NOTICE OF
CITY OF CELINA
PLANNING AND ZONING COMMISSION
CELINA COUNCIL CHAMBERS
112 N. COLORADO STREET
TUESDAY AUGUST 2, 2016
5:30 P.M.

To:	**The Celina Planning and Zoning Commission**
CC:	**Helen-Eve Liebman, Interim City Manager**
From:	Ben Rodriguez, Planner
Meeting Date:	August 2, 2016
Re:	Rezoning Request for Ace Hardware

To:	**The Celina Planning and Zoning Commission**
CC:	Helen-Eve Liebman, AICP, Interim City Manager
From:	Brooks Wilson, AICP, Senior Planner
Meeting Date:	August 2, 2016
Re:	Celina Professional Village Site Plan

EXHIBIT B

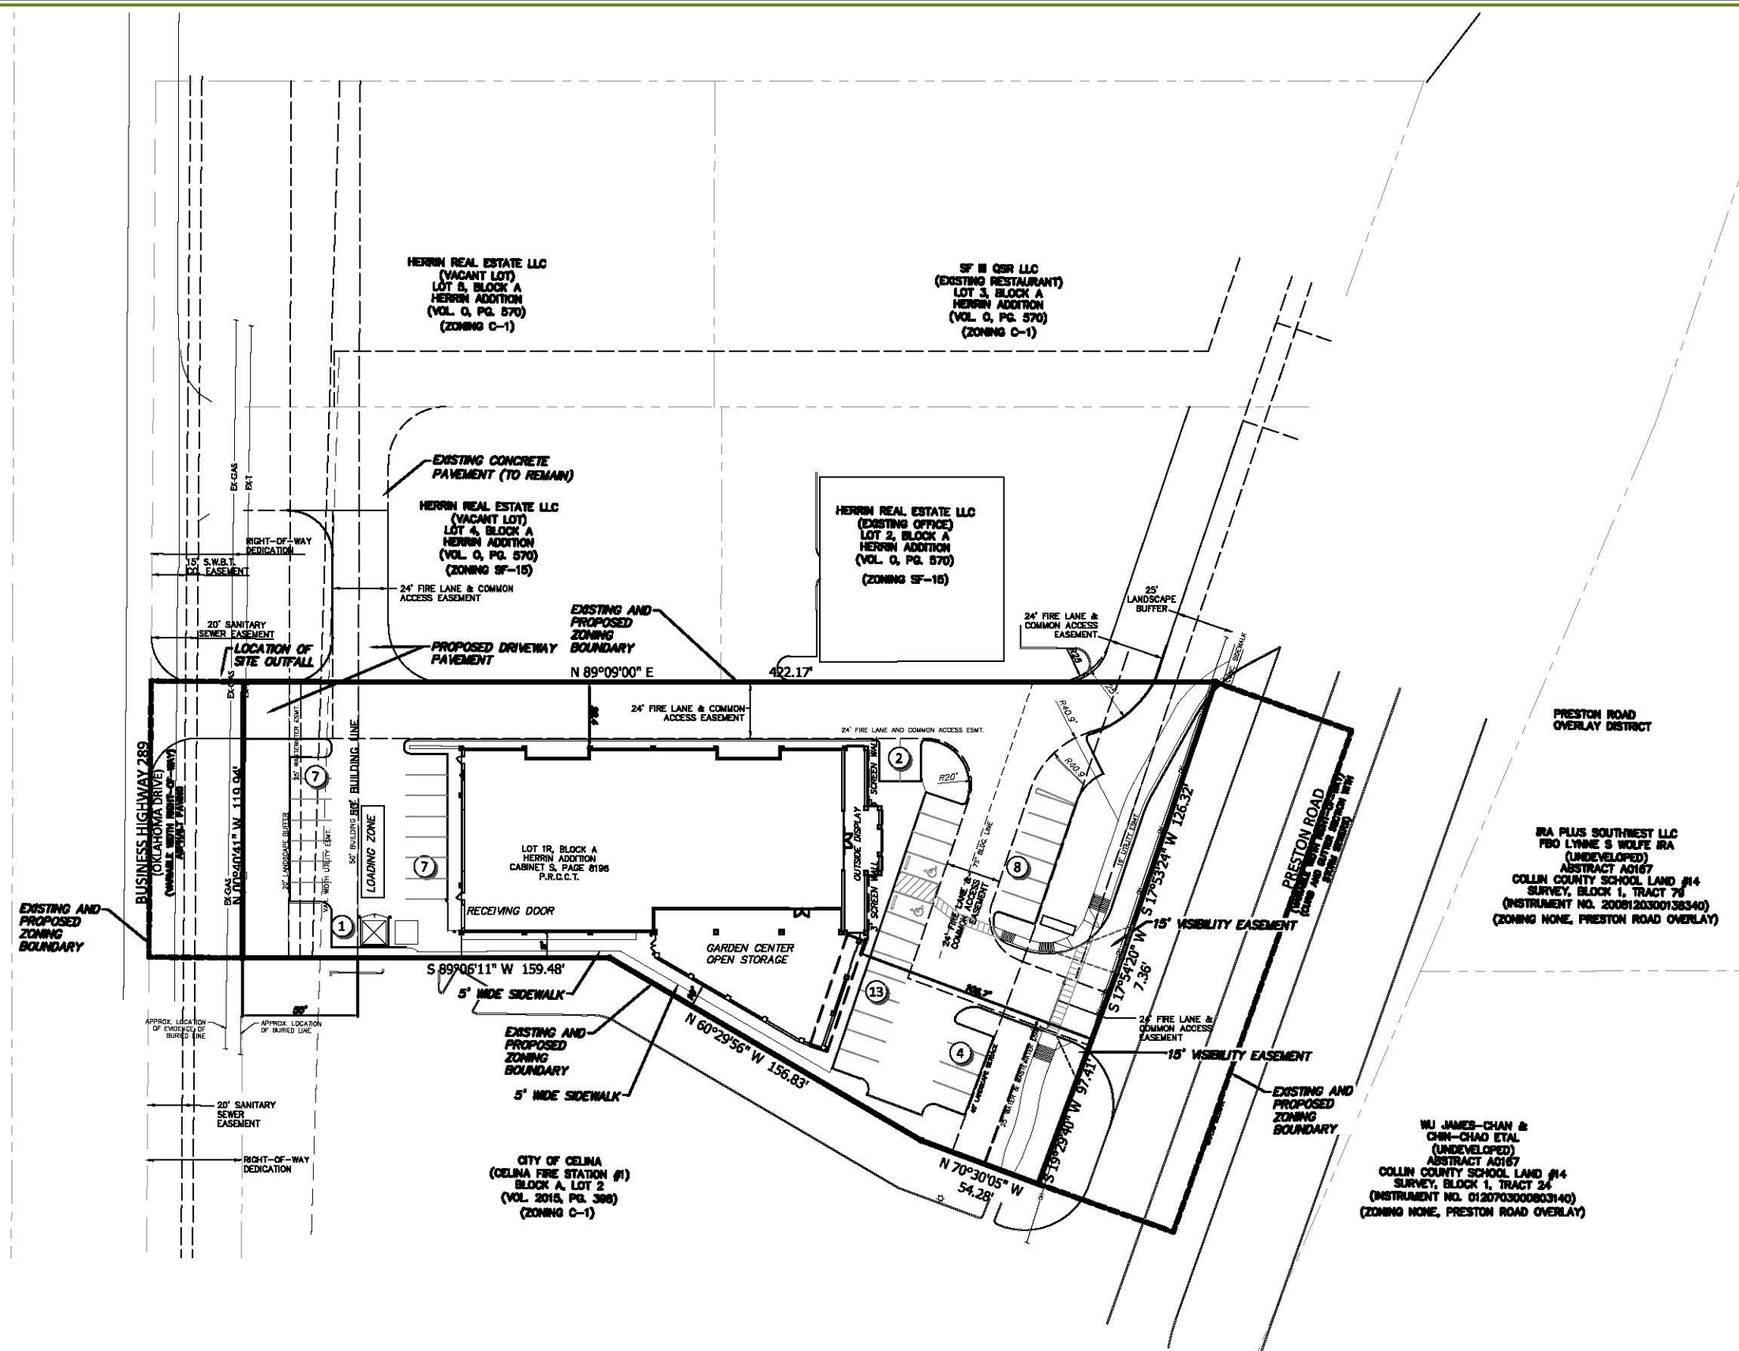
- Side yard buffer- The City's landscaping regulations require that a five foot landscape buffer be provided on the side yards of non-residential developments. Due to the shape of the lot and adjacency to the neighboring businesses, the applicant has requested that this requirement be removed so that their project may adequately fit on the site.

- Parking- The City's parking standards require 1 space per 300 square feet for retail uses, the applicant has requested approval for 1 space per 275 square feet. Given the nature of Ace Hardware's business, staff feels that this will provide adequate parking for the store.

(A) **Landscape Setback** – A 5' perimeter landscape set back is not a requirement for conditions in which a shared, previously platted, fire lane and access easement is located adjacent to a lot line common to two tracts that depend on the use of the shared fire lane and access easement.

(C) **Parking Spaces** Parking for the retail store shown on *Exhibit B* shall be at a rate of 1 parking space per 275 square feet of gross floor area. All other uses shall be in accordance with City standards, refer to article 14.05, Division 2.

EXHIBIT C

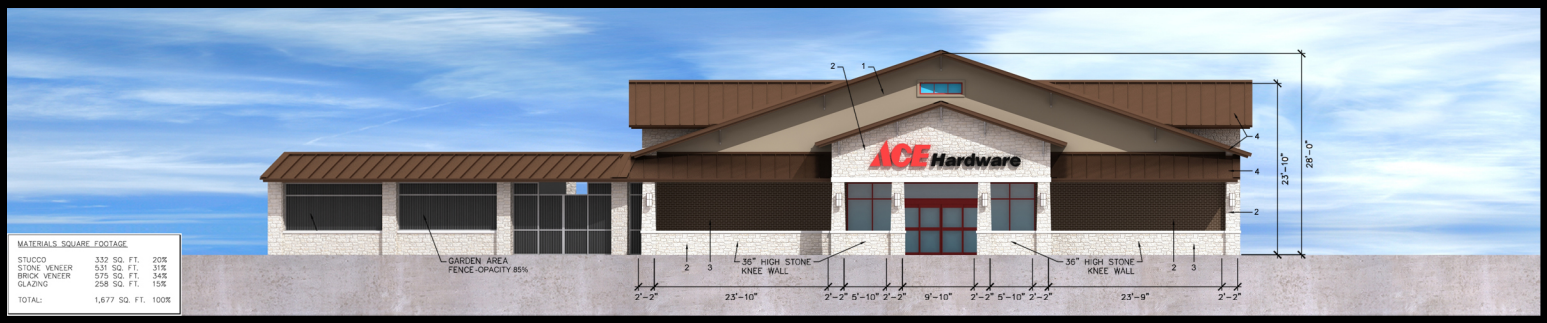
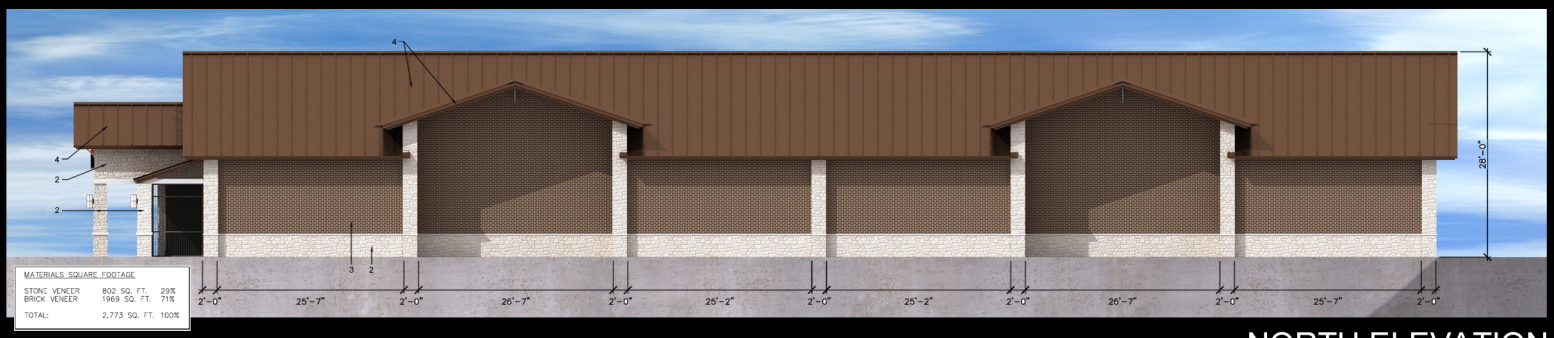
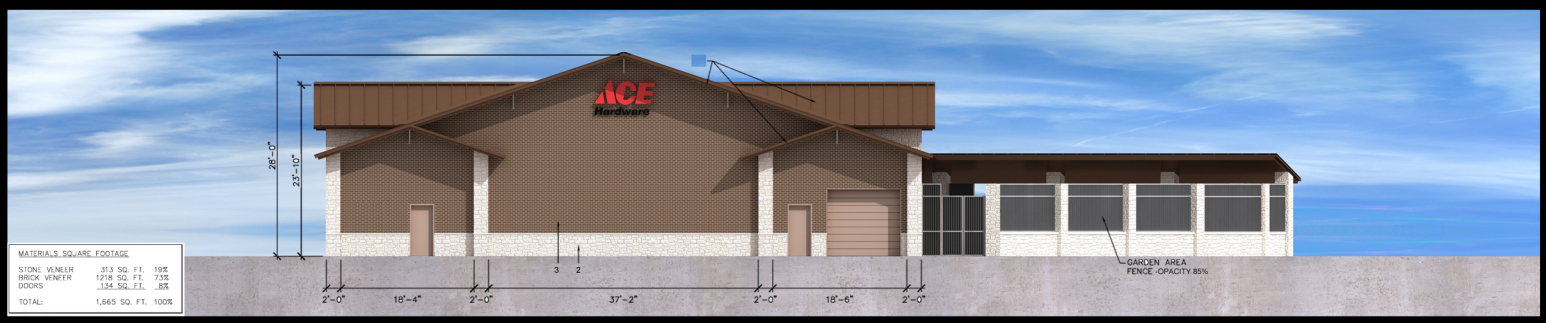
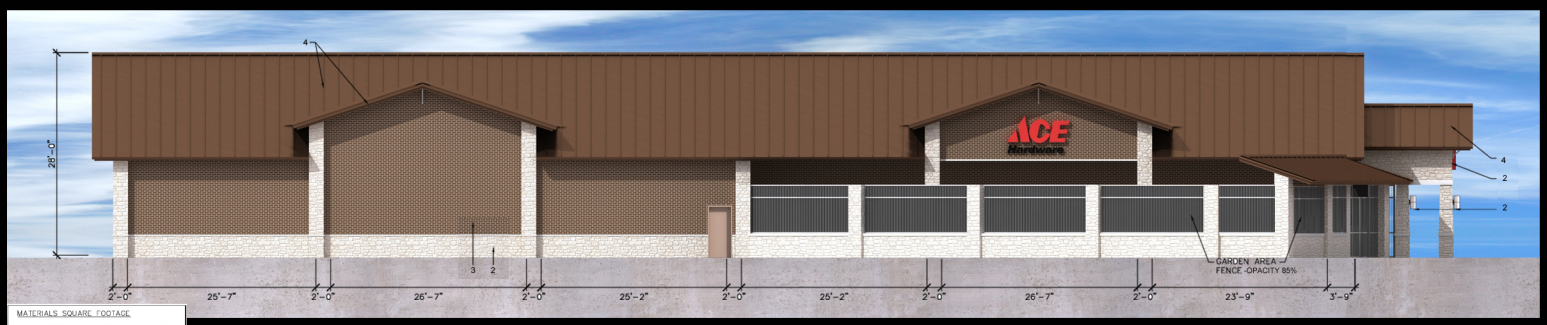
- Open storage- The City's base code requires that any open storage areas be screened by a masonry wall. The applicant has proposed a compromise in which the majority of the wall is comprised of masonry materials and the balance is comprised of a mesh material that is semi-transparent. This is a common way to screen "yard and garden" areas and staff supports the proposal.

(B) **Open Storage** Open storage will be allowed within the Garden Center as shown on Exhibit B. The Garden Center - Open Storage area will be enclosed with a 10-foot-high screening wall that will be a combination of 3 foot masonry base and wrought iron fence covered with mesh screening as shown on Exhibit C. All other uses shall be in accordance with City standards.

SITE PLAN

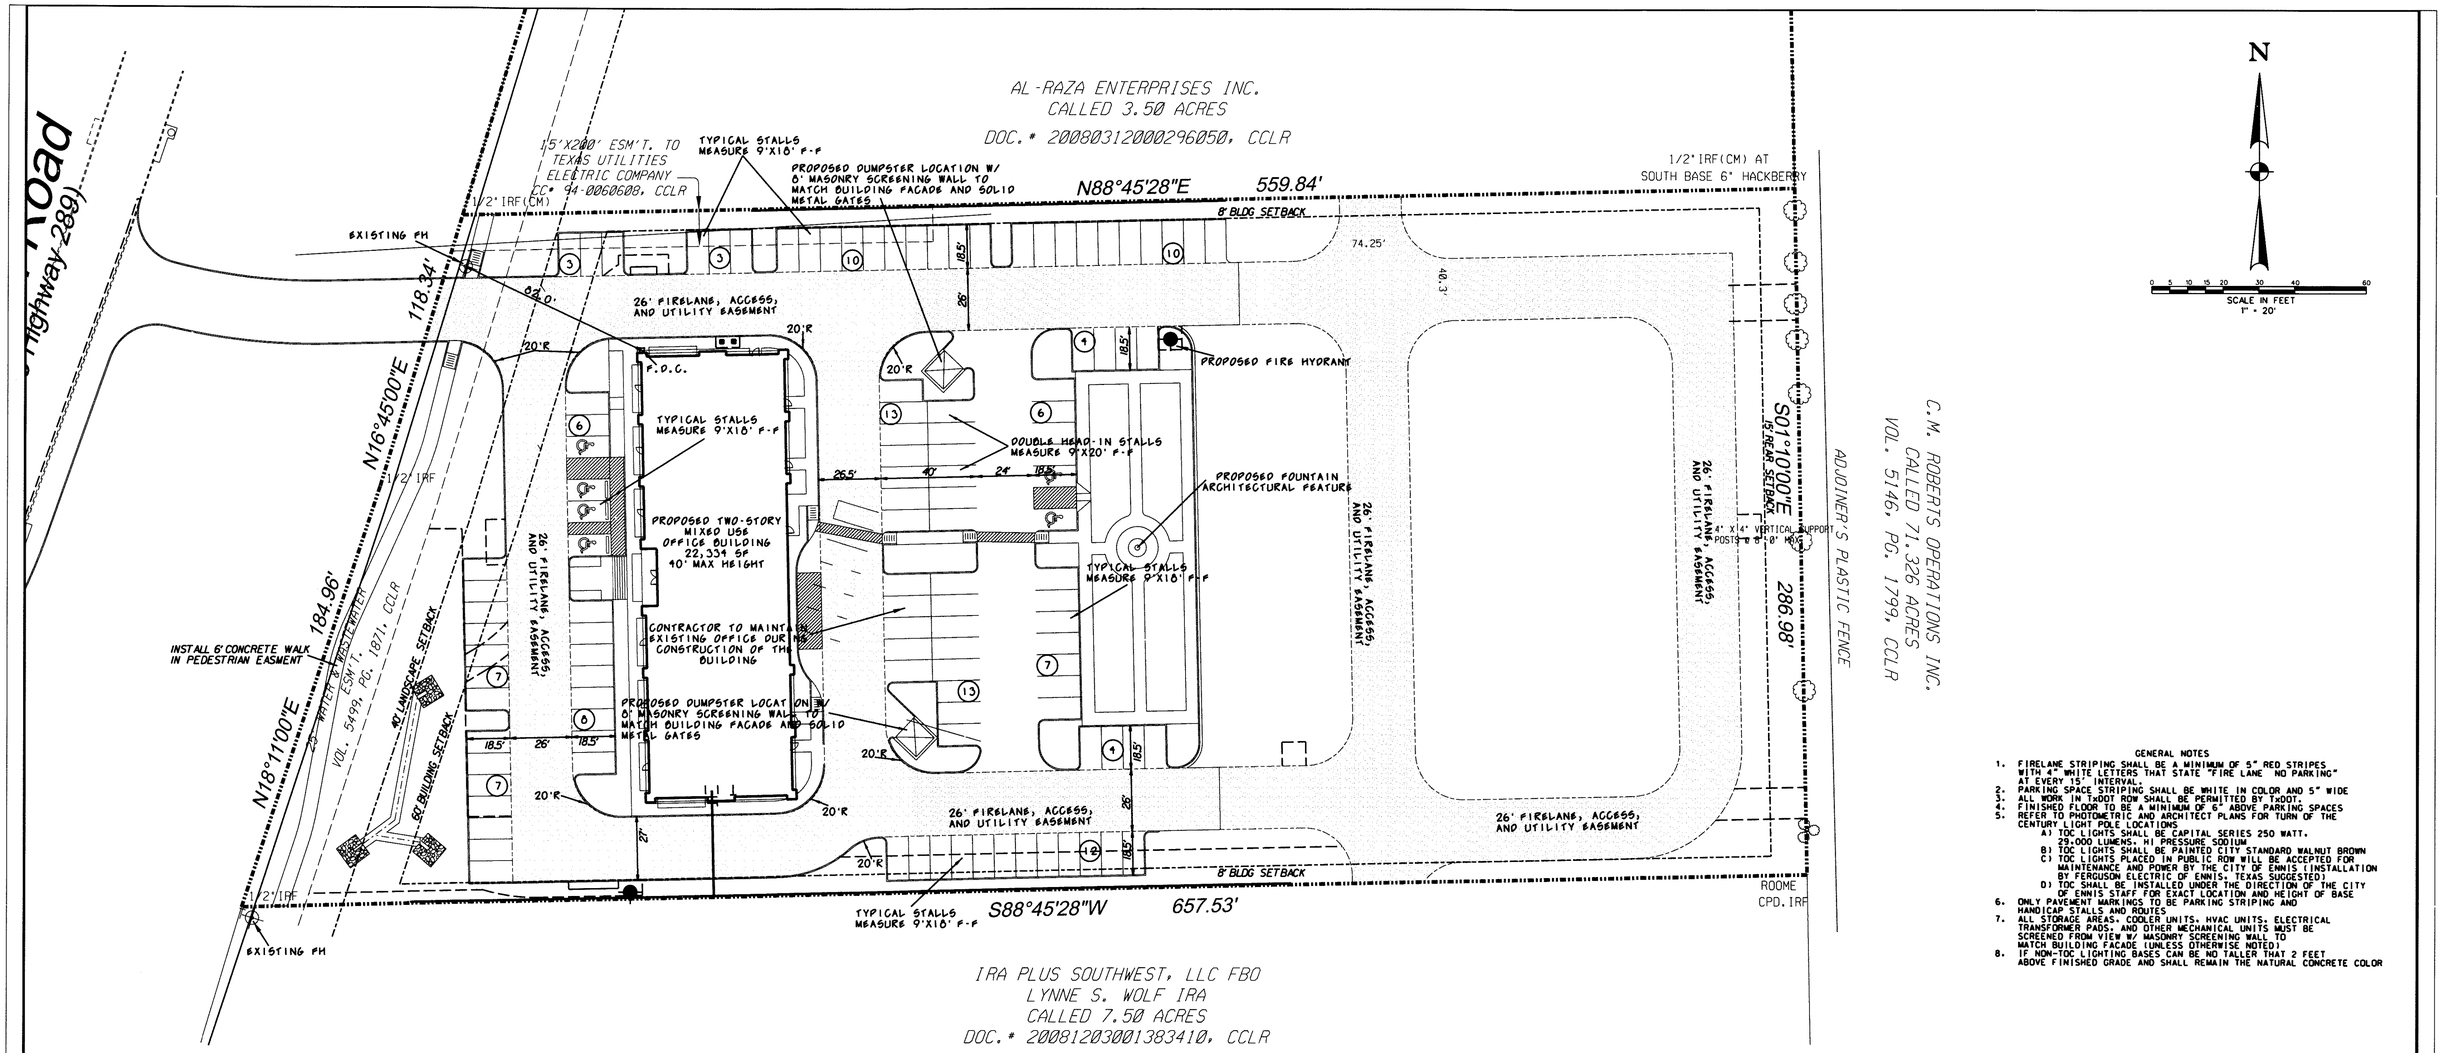
In this case, the natural slope of the property east of Preston Road is greater than is typically seen. The access drive must be constructed with an incline of less than ten percent (10%) per Fire Code. However, the access drive may be "cut into" the natural slope to achieve the required grade. Due to the topography of the site, the required cross access to future commercial development to the north and south of the subject property cannot meet the specific requirements in the Preston Road Overlay, Section 14.03.009(k)(2), which reads as follows:

> (2) Shared driveways/access. Developments shall incorporate a 24-foot wide shared access drive (via platted or properly recorded easements) through neighboring property(s), such that each lot or development site has at least two points of access to public roads. The required shared access drive shall be located adjacent to the required landscape buffer, and/or adjacent to the first bay of parking. (Ordinance 2014-20, sec. 3.03, adopted 5/13/14)

Because of the grade issue, the applicant is proposing the cross access farther east on the site, where the topography does not pose a safety problem for the construction of the access drives. The bump outs for the future access shall be constructed as part of Phase 2. Staff is in agreement with this proposal.
